Memorandum

To File: Sequoyah Fuels Corporation, O-Sand ISL Project, 13 R&D

Subject: Review of the Third Quarter 1987 Report for Sequoyah Fuels Corporation's O-Sand ISL R&D Project

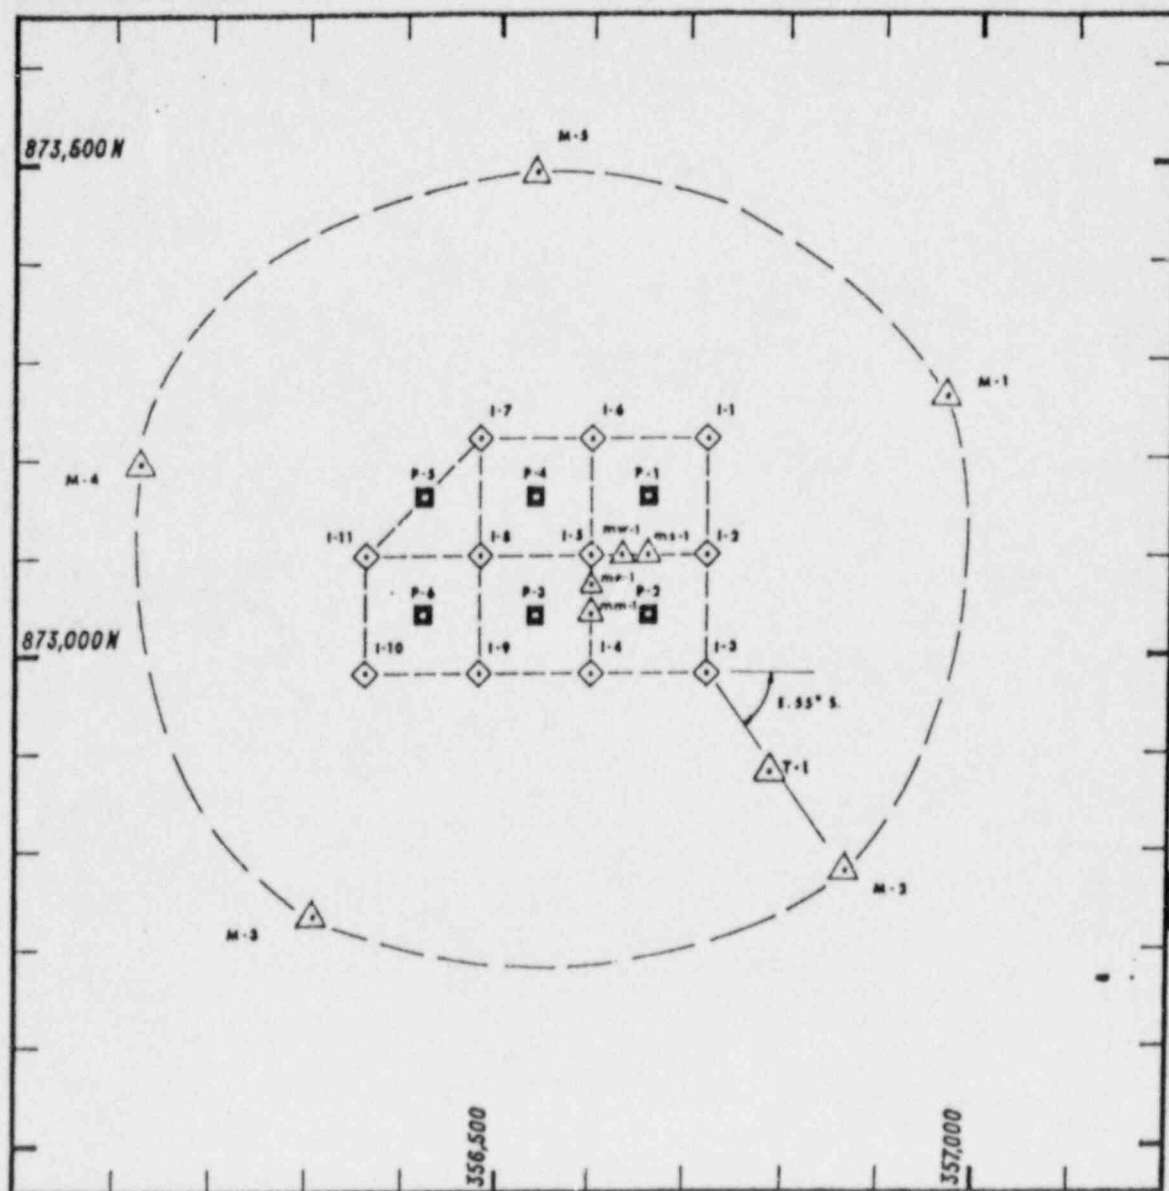
Table B-1 (Appendix VII) of SFC's quarterly report lists water level data for the 5 excursion monitoring wells and monitor wells: T-1 and MM-1. Because monitor well T-1 is situated between the O-Sand ISL injection/production wellfield and excursion monitoring well M-2 (see Appendix II) and completed in the same formations (see Appendix VI), a comparison of water levels measured on the same date for each of these wells will provide a useful indication of the localized hydraulic gradient existing in the O-Sand ISL wellfield. A review of water level data for these wells (see Appendix VII) indicates the regional hydraulic gradient caused by pumping at the Bill Smith Mine is greater than the localized gradient in the O-Sand ISL wellfield. Therefore, SFC's overproduction of 5% in the O-Sand ISL wellfield does not appear to be adequate to maintain a hydraulic gradient towards the test area.

as increasing, the reported data are verified, and if determined to be accurate, the percent over-production is increased as a preventive measure. As a means of facilitating an evaluation of operations at the O-Sand wellfield, SFC is requested to submit evidence that a hydraulic gradient exists towards the production zone of active ISL operations. SFC's submittal should include a potentiometric map of the O-Sand aquifer that encompasses the O-Sand R&D wellfield and the Bill Smith Mine wellfield.

APPENDIX V. Completion intervals for selected O-Sand wells.

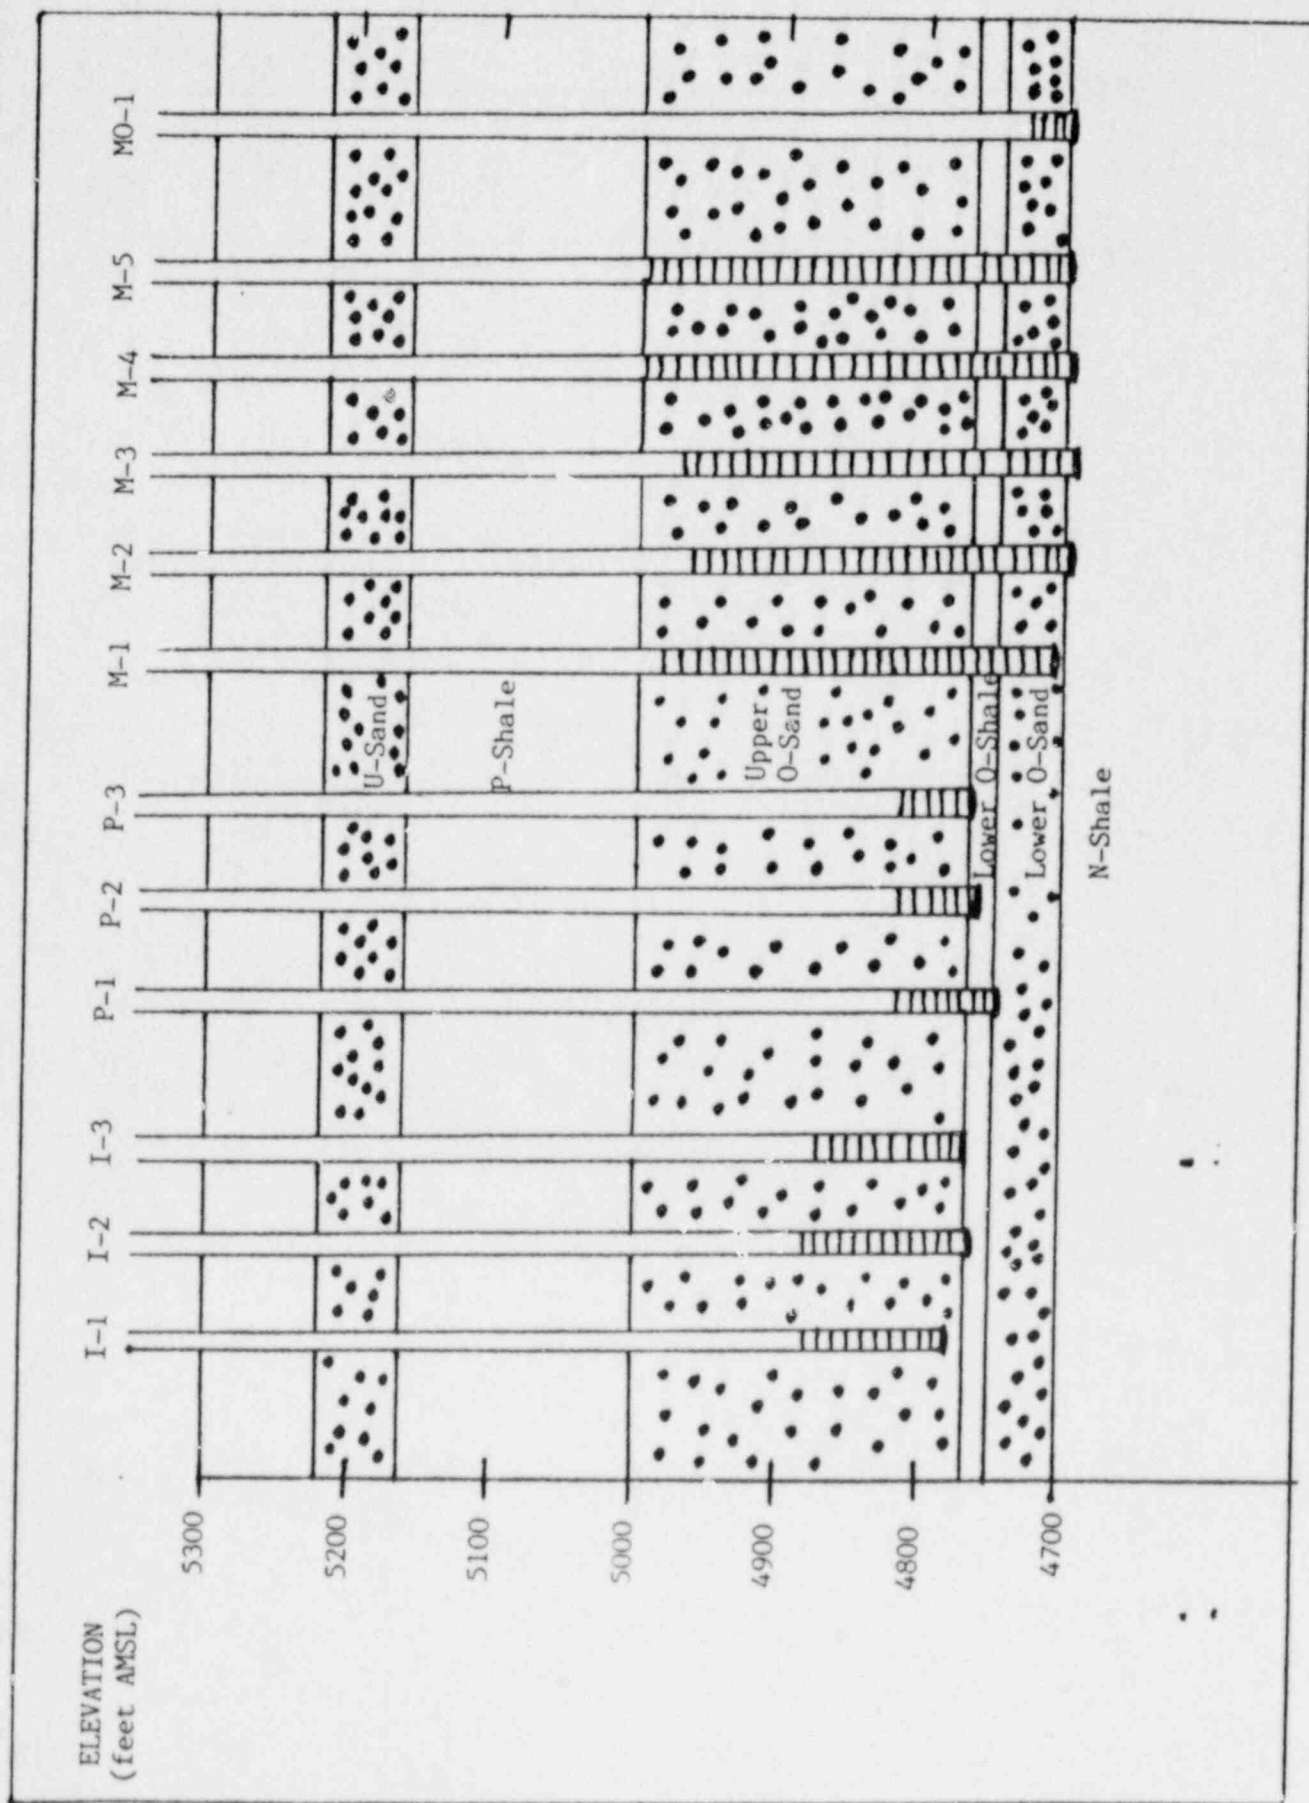
The excursion detection program does not appear to be adequately designed. Using completion interval data listed in Table 9-2 and O-Sand cross sections in Figures 9-3, 9-3a, and 9-4 of SFC's permit application, a well completion figure was developed (Appendix V). As displayed in Appendix V, the injection and production wells are completed in the upper O-Sand aquifer, while the monitor wells are completed in the upper and lower O-Sand aquifers. Comparison of baseline water quality data collected from well MO-1 (completed solely in the lower O-Sand aquifer) with baseline data collected from the injection and production wells (completed in the upper O-Sand aquifer), indicate that water quality of the lower O-Sand aquifer consists of lower concentrations of bicarbonate, sulfate and TDS (as indicated by conductivity) than the upper O-Sand. The following conclusions are drawn from a review of Appendix V and SFC's baseline water quality data:

- the lower O-Sand and upper O-Sand are two distinct aquifers with respect to water quality;
- an overproduction in the O-Sand ISL test area may cause water from the lower O-Sand to move into the upper O-Sand as a result of multiple-completed monitoring wells;
- in the event an excursion is detected, pumping of the monitoring wells, as a remedial measure, will involve water removal from both the lower and upper O-Sand aquifers;
- mixing of waters from the lower and upper O-Sand aquifers will most likely result in lower values of bicarbonate, sulfate, and conductivity in samples collected from the monitoring wells as compared with samples collected from these monitoring wells had they been exclusively completed in the upper O-Sand; therefore, excursions may proceed undetected.

1. An evaluation of whether the percent over-production maintained at the O-Sand ISL test area is adequate to ensure a hydraulic gradient exists towards the test ISL wellfield. Supporting materials should include a potentiometric map of the O-Sand ISL test area and the Bill Smith Mine.
2. A plan for re-completion of monitor well numbers M1 through M5 to ensure that these wells are exclusively completed in the "upper" O-Sand.
3. Subsequent quarterly reports are to provide UCL parameter units as indicated in this memorandum.
